PARTS & SERVICE NEWS

REF NO. AA01081

SUBJECT: NEW CYLINDER LINERS FOR NEW PRODUCTION 114 SERIES BLOCKS

PURPOSE: To introduce a production change in cylinder block machining.

Fig. 2, New Liner/New Block

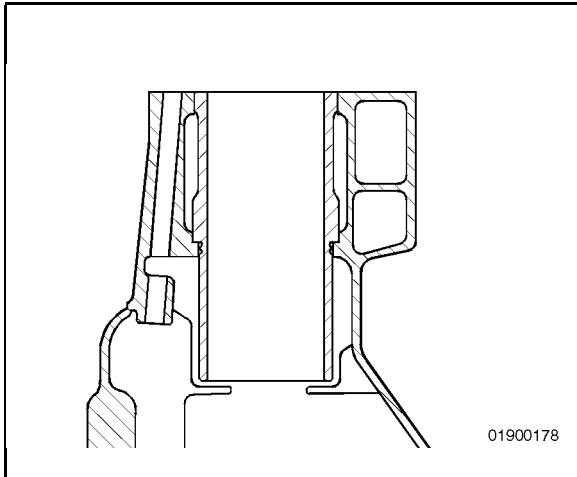
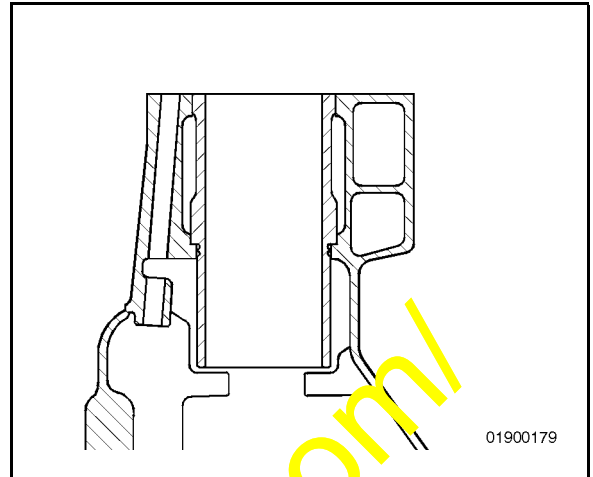
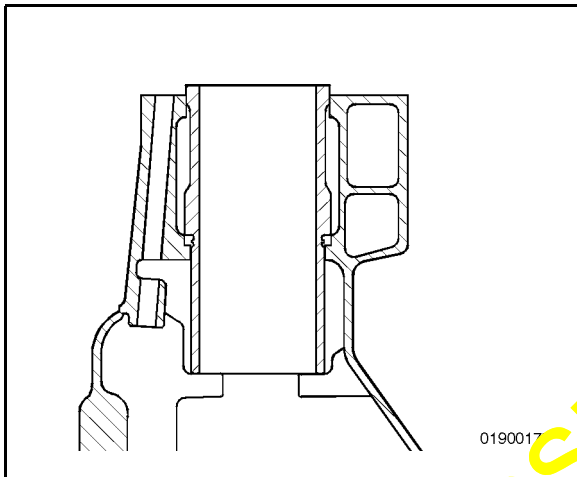
This Parts & Service News introduces a new cylinder liner for 114 engine series with modified blocks that stop 3mm shorter than the old block (refer to Fig. 1 and 3).

The new cylinder liner part number 6742-01-5159 is 3mm shorter than the old, part number 6742-01-1500. The old liner in a new block will sit above the head deck by about 3mm, which is unacceptable (refer to Fig. 3). Therefore, **when replacing 114 Series blocks, the liner must also be replaced.** However, the old Part No. 6742-01-1500 will be retained as a service part for engines built prior to the engine serial numbers listed below.

WARNING! Replace a cylinder liner only with an identical one. Only use the new cylinder liner on new 114 Series blocks.

When replacing liners within the old 114 Series block (**not replacing the block**), liner kit, Part No. 6742-01-1500, is still available with the old liner.
